## **HEAT PUMP UNITS**

506906-01 10/2011

## SUPPLEMENT TO KHA024-240 UNIT INSTALLATION INSTRUCTIONS

FIGURE 1

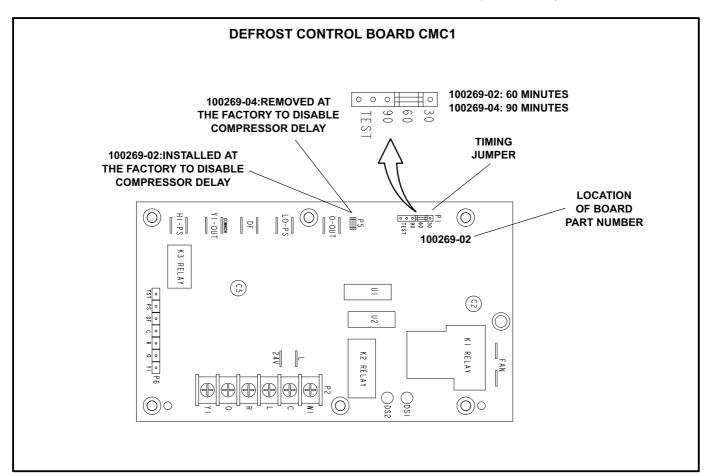
This unit may contain either a 100269-02 or a 100269-04 CMC1 defrost control board. The function of the defrost timing jumper and compressor delay jumper are different depending on which board is installed. See figure 1 for the location of the board part number, defrost timing jumper and compressor delay jumper.

100269-02

The defrost timing jumper is set at **60 minutes**.

The compressor delay jumper is **installed** at the factory to disable the compressor delay.

100269-04

The defrost timing jumper is set at 90 minutes.

The compressor delay jumper is **removed** at the factory to disable the compressor delay.
